Access Compliance Report Public Rights-of-Way (Curb Ramps)

Intersection ID: 10662	Main Street: E_36TH_ST	Cross Street: HOLT_ST	Location: S
ADA ID: DA47B9D5989B	Ramp Type: ParaDiag	Initial Pass/Fail: Pass	Overall Compliance: No Severity Score: 12.75

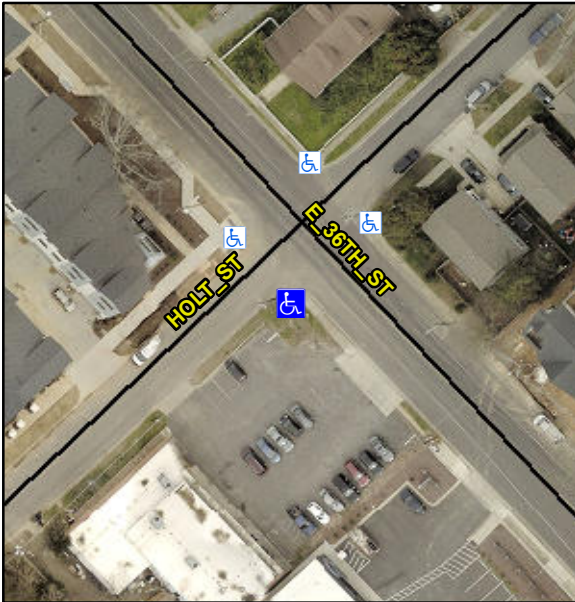
RT RP < 5%

R304.5.3, R304.2.2-Perp, R304.3.2-Para, R305.2, R302.7.2, R304.5.4

Compliance	Description	Data	Compliance	Description	Data
N/A	Ramp Length LT (in)	40.0	N/A	Ramp Length RT (in)	25.5
Yes	Ramp Width LT (in)	59.0	Yes	Ramp Width RT (in)	59.0
Yes	Ramp Slope LT (%)	6.3	Yes	Ramp Slope RT (%)	2.0
No	Ramp XSlope LT (%)	2.1	Yes	Ramp XSlope RT (%)	1.8
Yes	Landing Length (in)	59.5	Yes	DWS Provided?	Yes
Yes	Landing Width (in)	48.0	Yes	DWS Contrast?	Yes
No	Landing Slope (%)	4.1	Yes	DWS Length (in)	24.5
No	Landing X Slope (%)	3.7	Yes	DWS Full Width?	Yes
N/A	Landing Curb? (Y/N)	No	No	DWS Offset (in)	4.0
N/A	Shared Landing?	No			
Yes	Gutter Ponding?	No	No	Gutter Slope (%)	9.4
No	Gutter Lip Ht (in)	0.5	No	Gutter X Slope (%)	4.4
N/A	Painted X Walk1?	No	N/A	Painted X Walk2?	No
	X Walk 1 Direction	To NE		X Walk 2 Direction	To NW
N/A	X Walk 1 Width (in)	N/A	N/A	X Walk 2 Width (in)	N/A
	X Walk 1 Slope (%)	2.2		X Walk 2 Slope (%)	1.1
	X Walk 1 X Slope (%)	1.3		X Walk 2 X Slope (%)	1.2
N/A	Ramp inside XWalk1?	N/A	N/A	Ramp inside XWalk2?	N/A

Remove & Replace Curb Ramp With Two New Directional Ramps or Equivalent. Remove & Replace Gutter.
